Date: 10/12/21

ADDENDUM # 1

St. Cloud HRA

Wilson Apartments - Accessibility Upgrade

NORTH	DATE	09/28/2021
	PROJECT	2107
		A1

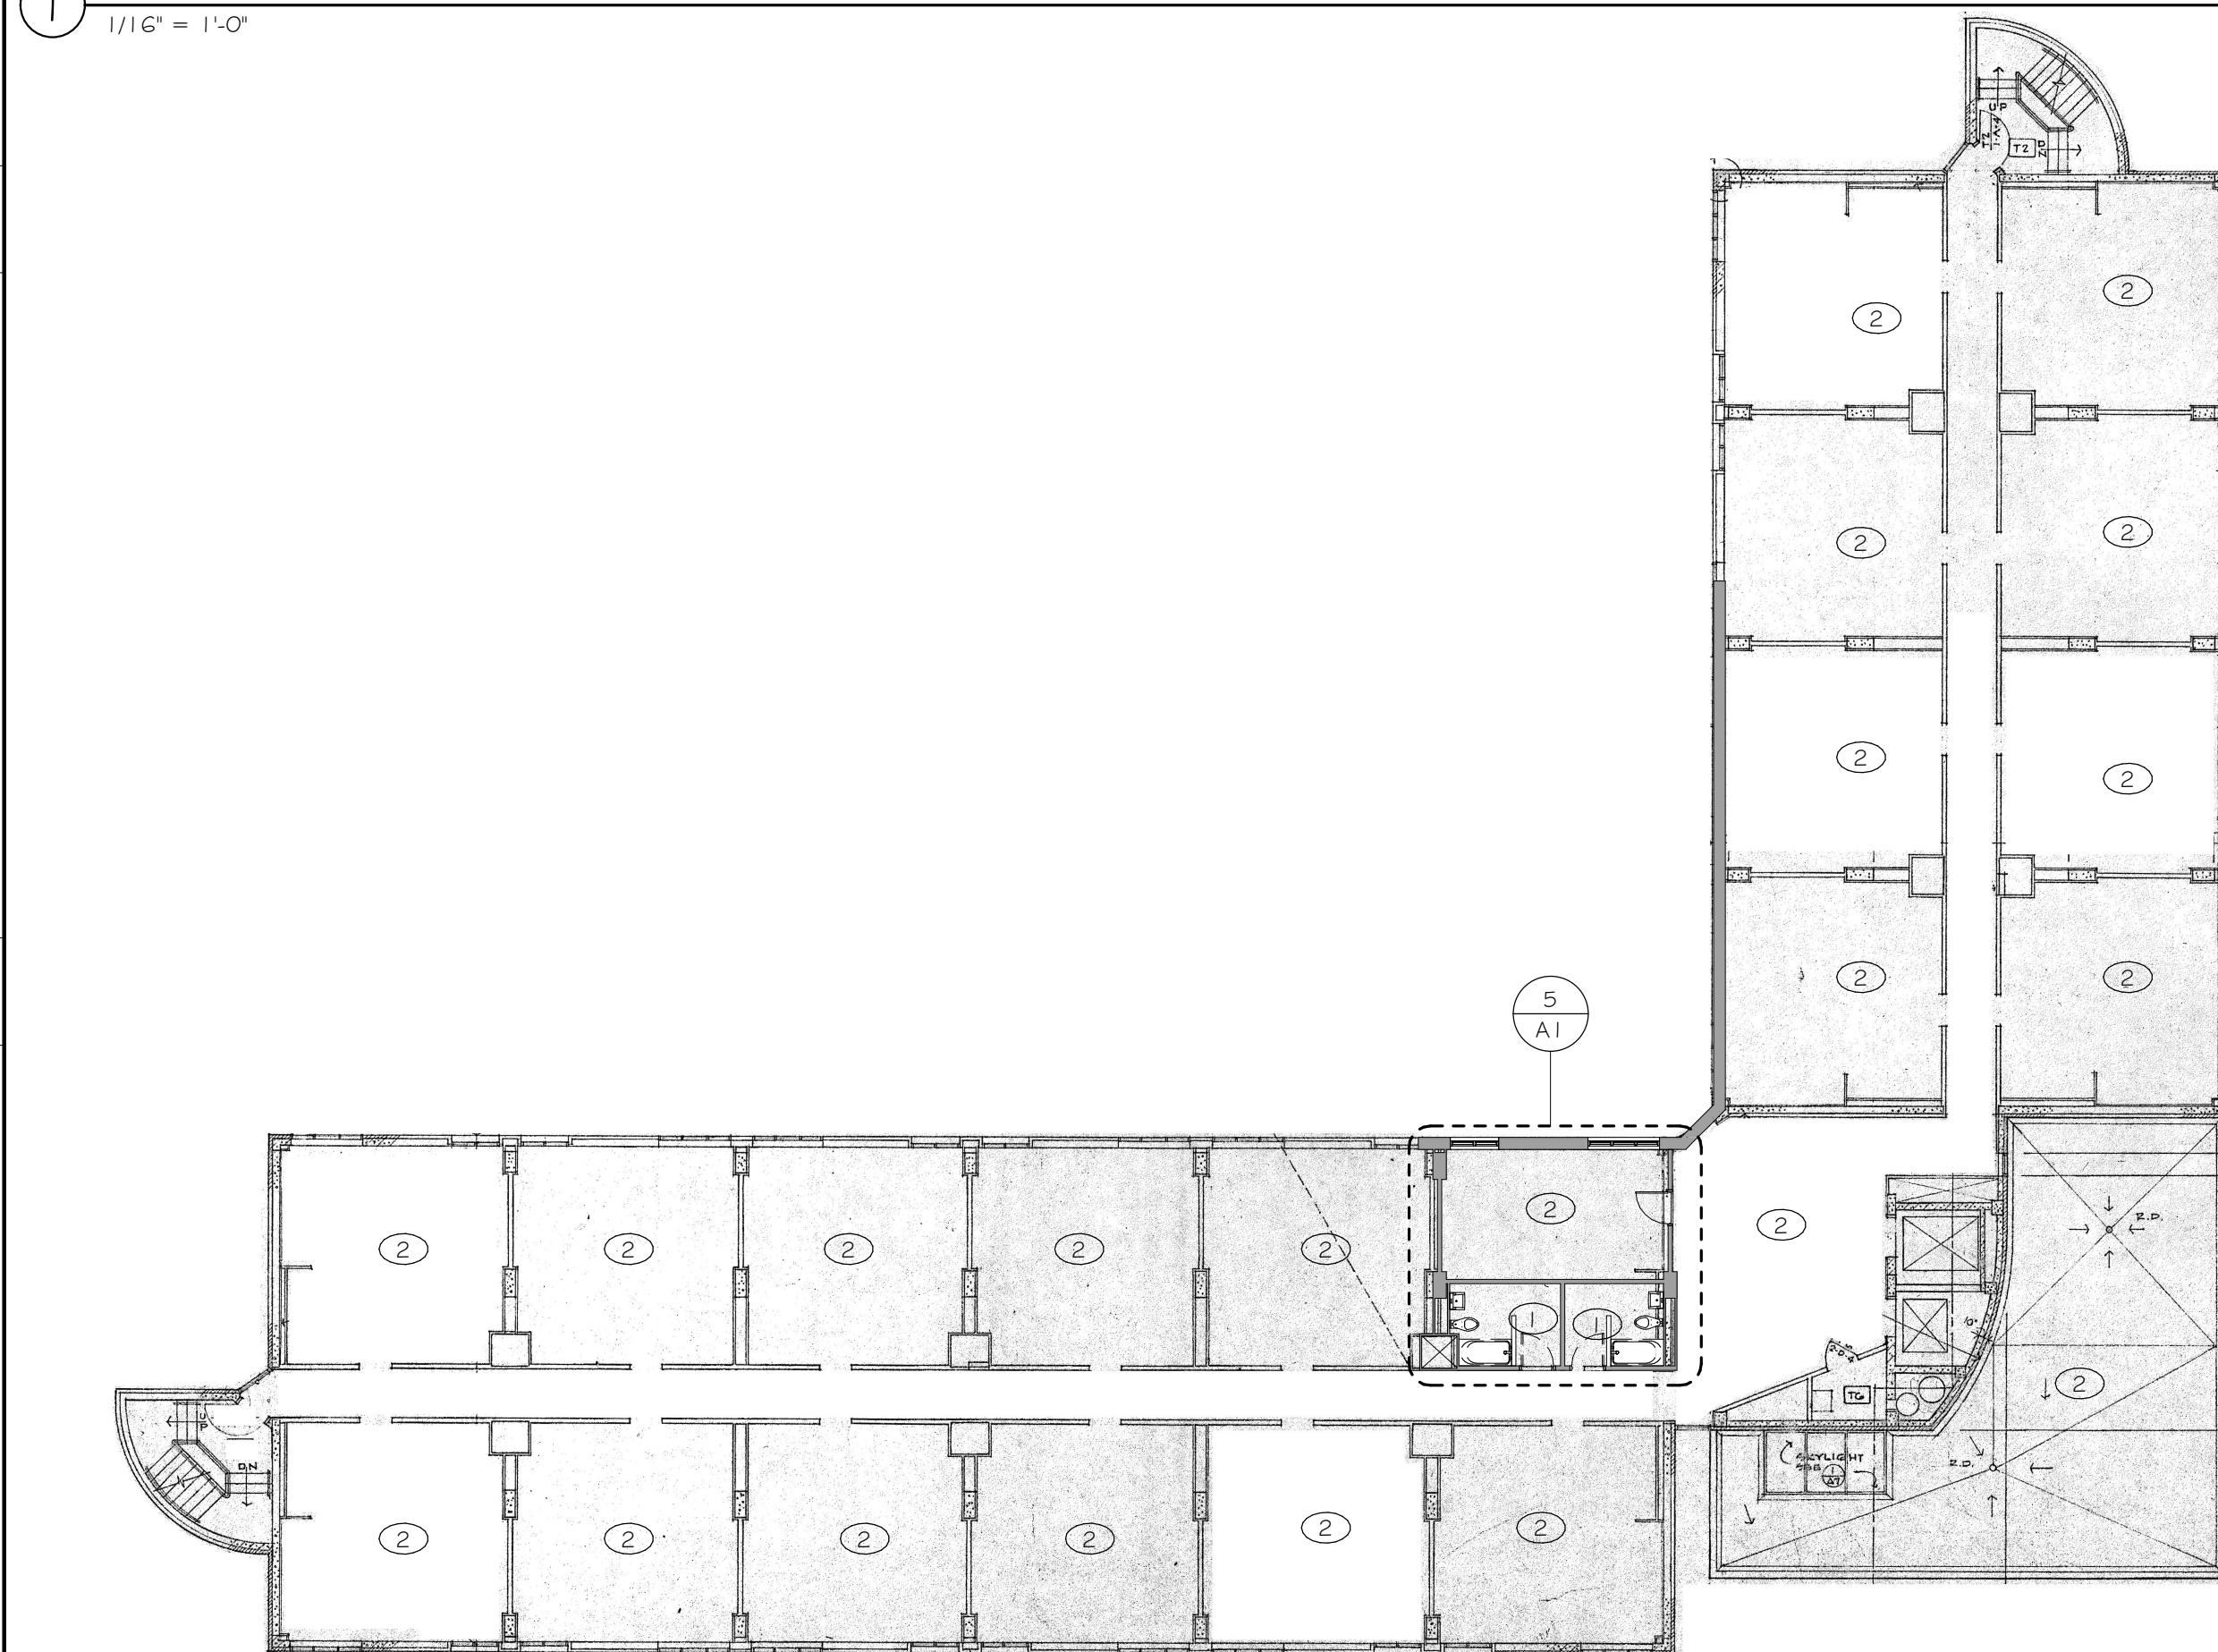
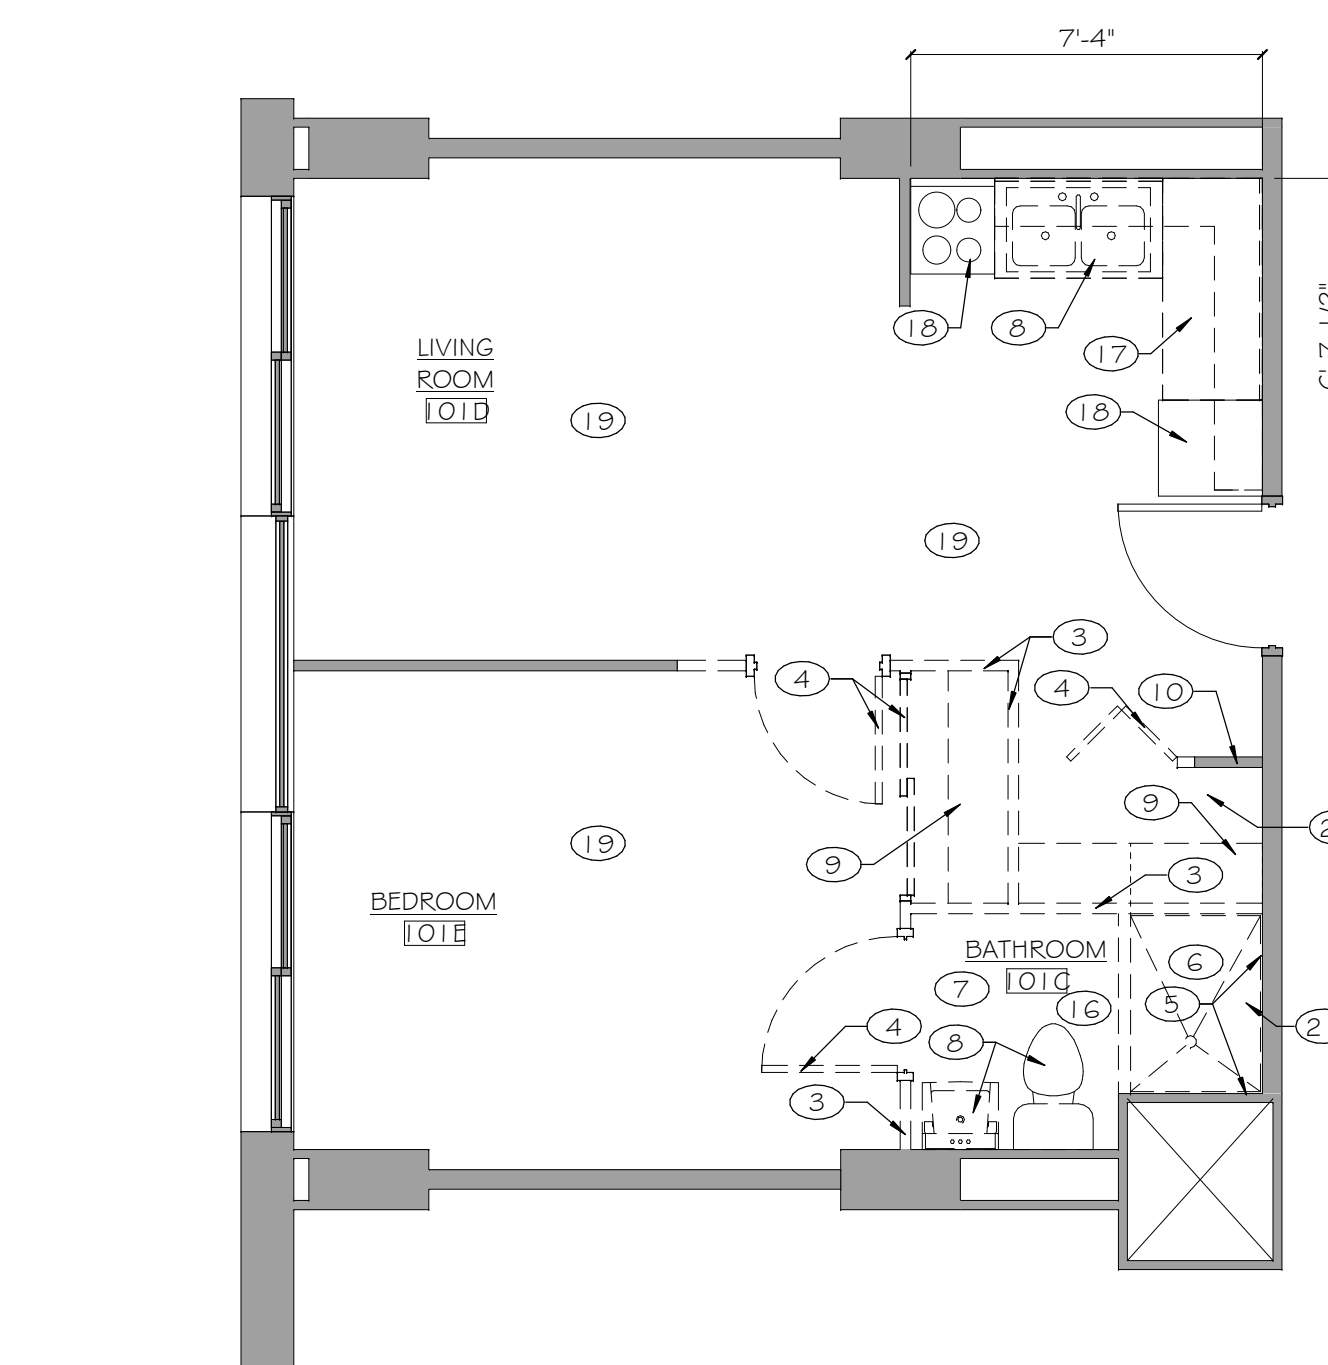
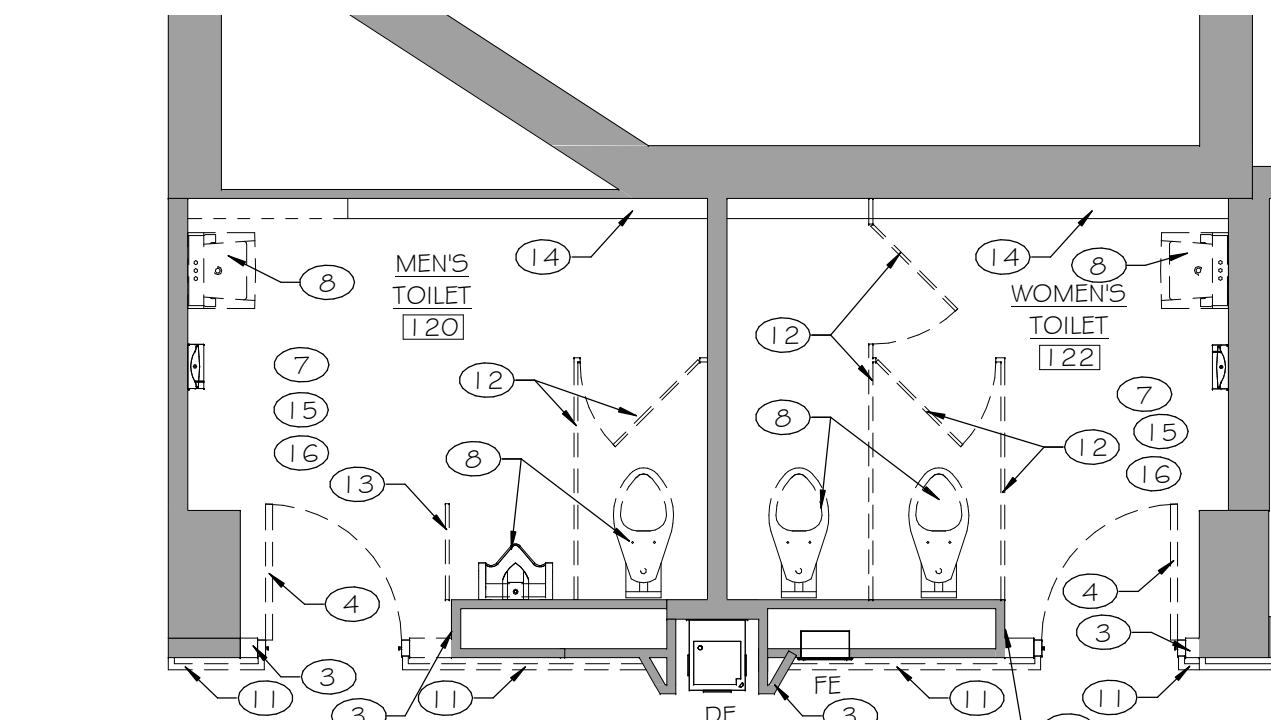
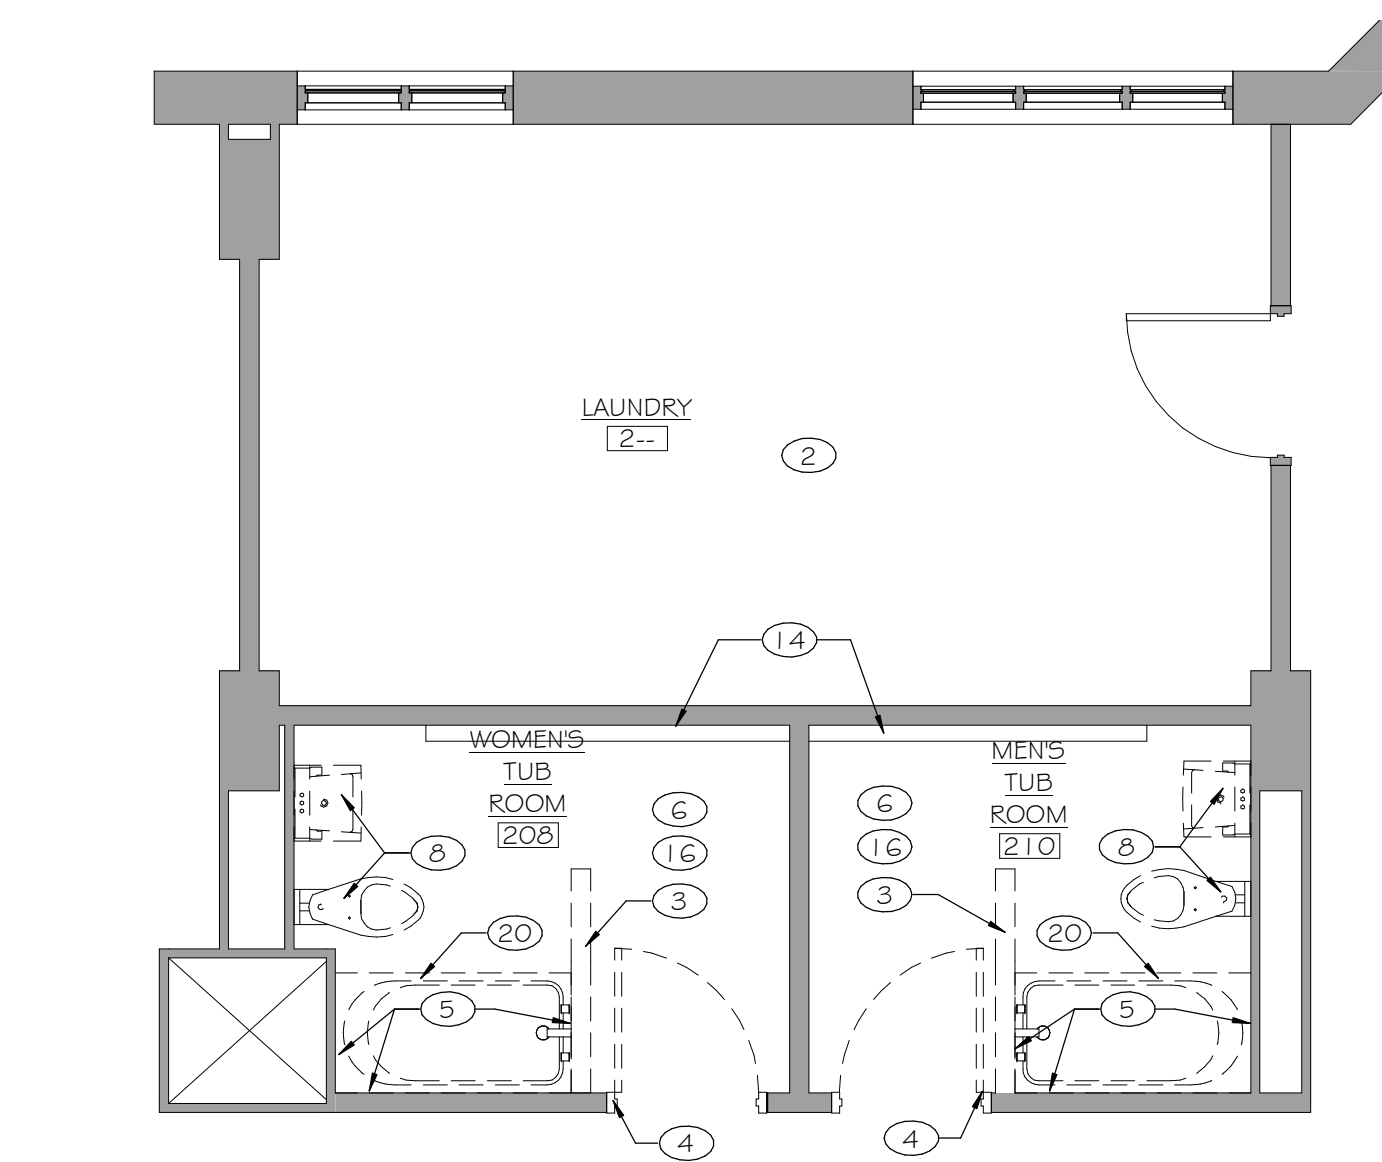
A. Sheet A1.

1. See demolition key notes for items to be removed by abatement contractor.

- REMOVE CASEWORK.
- EXISTING APPLIANCE, RELOCATE DURING CONSTRUCTION.
- EXISTING ACT FLOORING TO REMOVED BY ABATEMENT CONTRACTOR
- REMOVE BATHTUB.
- REMOVE CONCRETE SLAB FOR NEW SHOWER FLOOR

- EXISTING VCT FLOORING AND BASE TO BE REMOVED BY ABATEMENT CONTRACTOR
